Subject: Communications Report Transmittal #11
Comanche Peak Steam Electric Station
Independent Assessment Program - Phase 3
Texas Utilities Generating Company
Job. No. 84042

Communications Report

Company:	Texas Utilities	<input type="checkbox"/> Telecon	<input type="checkbox"/> Conference Report
Project:	Comanche Peak Steam Electric Station	Job No.	84042
	Independent Assessment Program - Phase 3	Date:	6/14/84
Subject:	Oversize Bolt Holes (Pipe Supports)	Time:	9:20
	(Item 25 in 5/24 Telecon)	Place:	Site
Participants:	R. Sievers	of	B&R
	J. Minichiello		Cygna

Subject **# CC-1-031-008-533R**

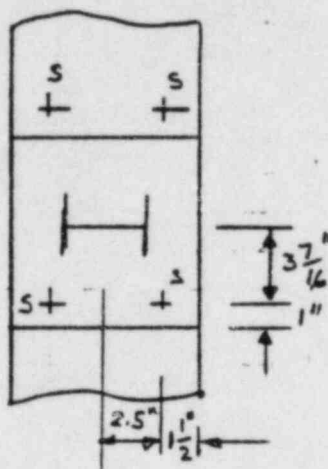
Item	Comments	Required Action By
1.	<p>Cygna requested response to the following two questions.</p> <p>In CC-1-031-008-S33R, Cygna has noted another instance of a "fixed" joint at an embed plate, rather than a "pin" joint (see comments on MS-1-004-001-C72S, dated 3/21). In this case, a "fixed" assumption is needed, since self-weight was considered. The Civil Spec (SS-30) requires stiffeners be provided (see attached).</p> <p>a. Is piece 7 considered to be the stiffener?</p> <p>b. Has the Civil Group provided guidelines for stiffeners?</p> <p>c. What direction has TUSI given the support designers in using embed plates as "fixed" connections?</p> <p>d. The designer appears to use conservative calcs in determining plate loads. Then, he uses the highest plate allowables. What is TUSI's direction for determining embed plate allowables?</p>

- 3.4 "Pin Connections" shall be assumed for load transfer to the embedded plates. Only forces normal to the embedment (P) and forces in the plane of the embedment (S) may be transferred to the embedment. Moments due to cantilever action or from any other source may be transferred to the embedment only when the embedment is stiffened for the calculated moment.

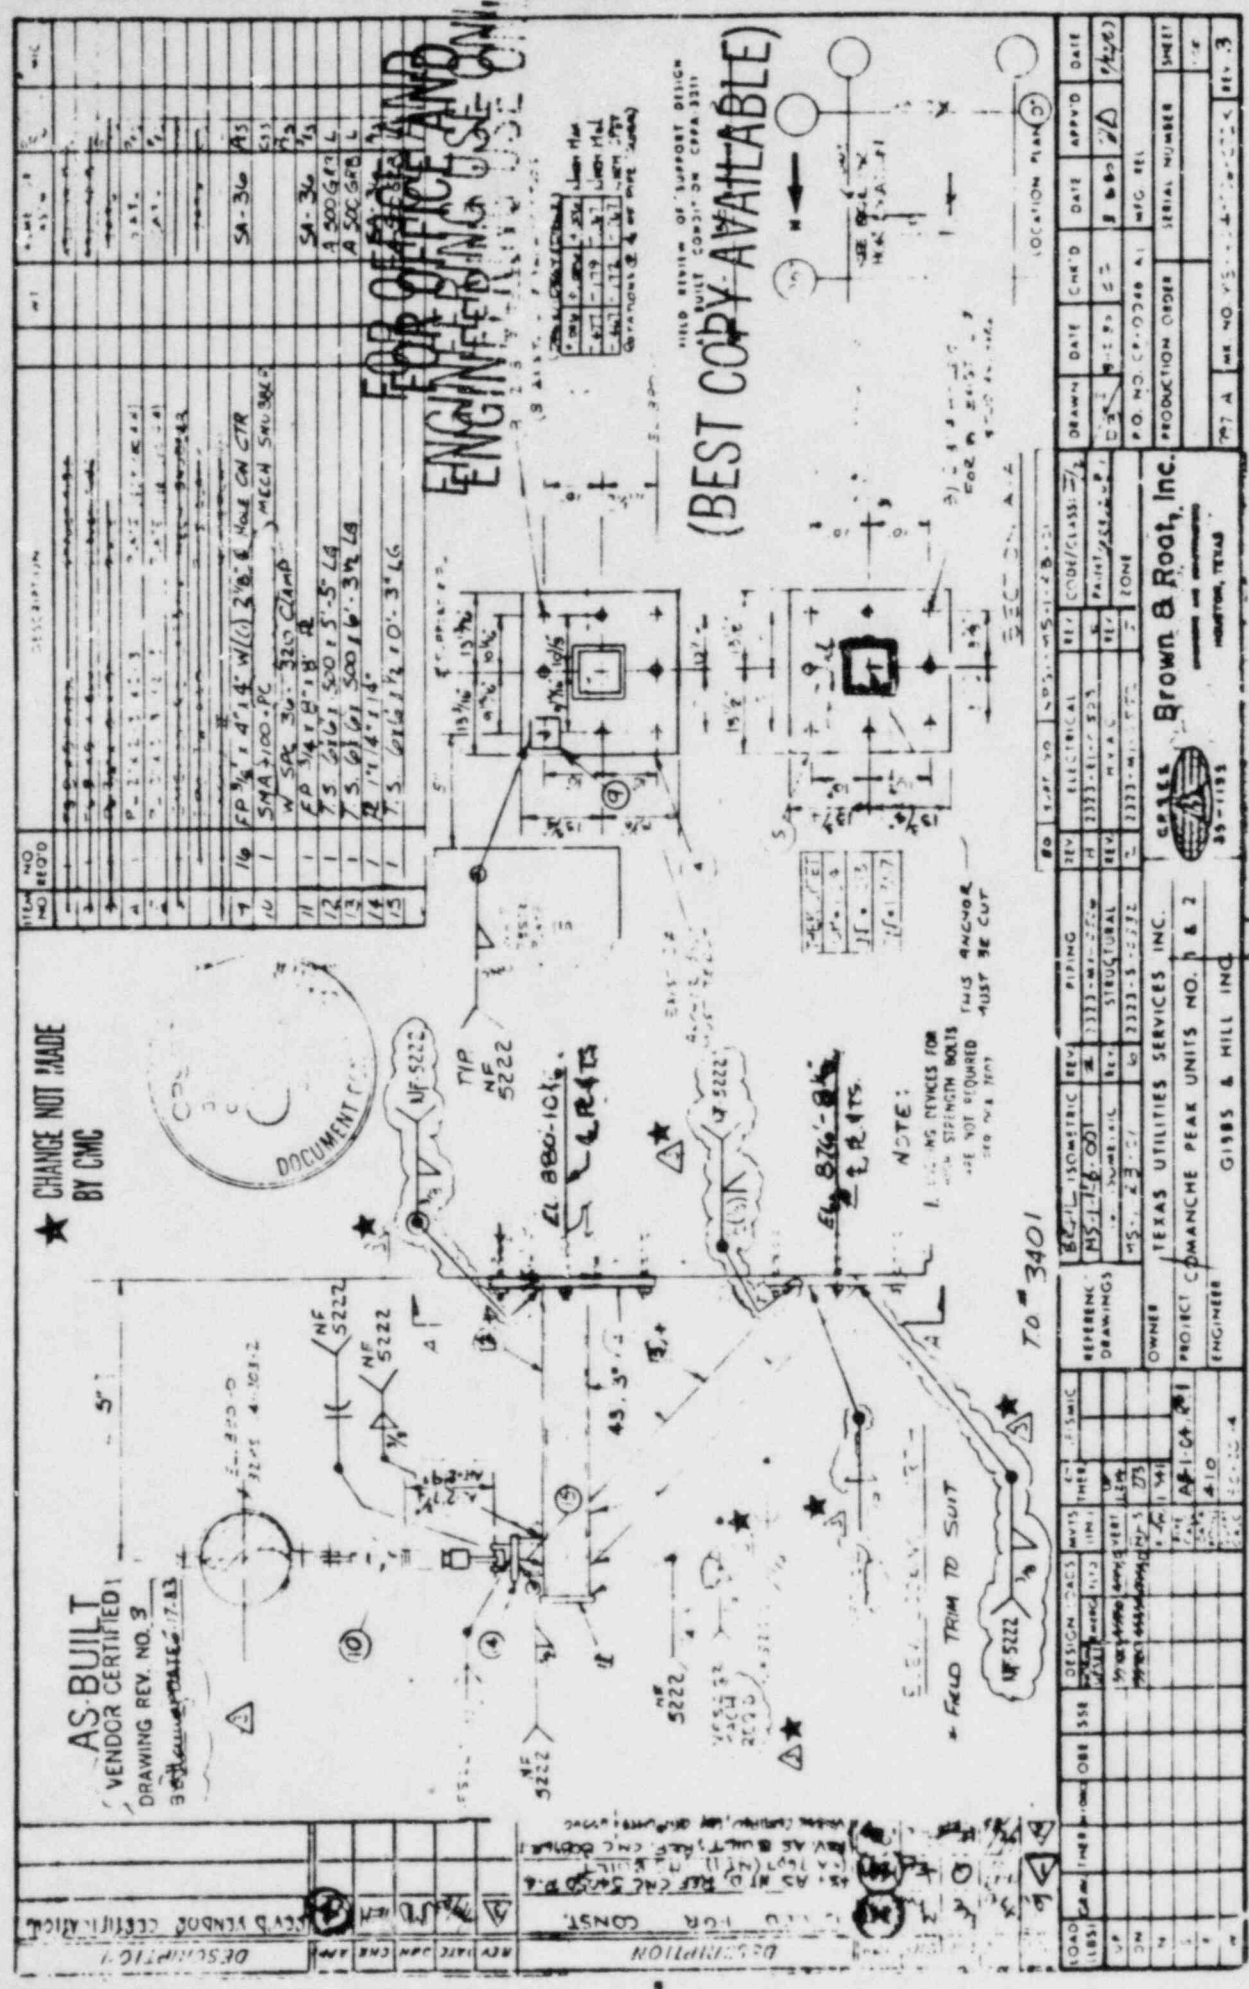
Item	Comments	Required Action By
	In response to Cygna's question on MS-1-004-006-C72K (see conf. report 6/15/84), Texas Utilities ran a finite element model of the connection. Their response is attached.

$$22,540 \text{ psi} \leq 0.75(32,040) = 24,030 \text{ psi. } \text{ok} \checkmark$$
